Item Name: Replacement Skidtube (Fits LH or RH)

DRAWING NO. D2650	TITLE 206/407 SKIDTUBE ASSEMBLIES	REV. F	DART AEROSPACE LTD ENGINEERING ORDER		D.E.O. NO. D2650-F-1	SHEET NO. SHEET 1 OF 1	SCALE NTS
DRAWN <i>[Signature]</i>	CHECKED <i>A.P.</i>	MFG. APPR. <i>[Signature]</i>	APPROVED <i>[Signature]</i>		DE APPR. <i>[Signature]</i>		
DATE 12.10.12	DATE 12.10.22	DATE 12.10.22	DATE 12.10.22		DATE 12.10.22

CHANGE C'BORED WELDED CROSSBOLT SPACERS TO SWAGED SPACERS

DETAIL B

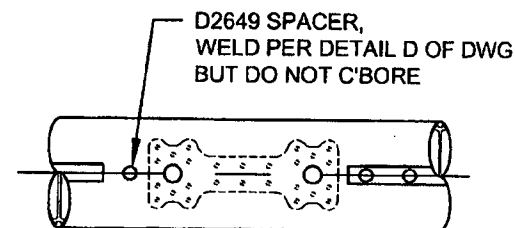
17	18	19	23	D2649	CROSS BOLT SPACER
----	----	----	----	-------	-------------------

ADD DETAIL G BELOW, WHICH IS THE SAME SECTION VIEW AS DETAIL D OF DWG.
C'BORED HOLES ARE **NOW SWAGED** PER DETAIL G BELOW. FOR THE Ø0.375 HOLE THAT IS NOT C'BORED, WELD PER DETAIL D OF DWG (SEE AMENDED DETAIL B FOR REFERENCE).
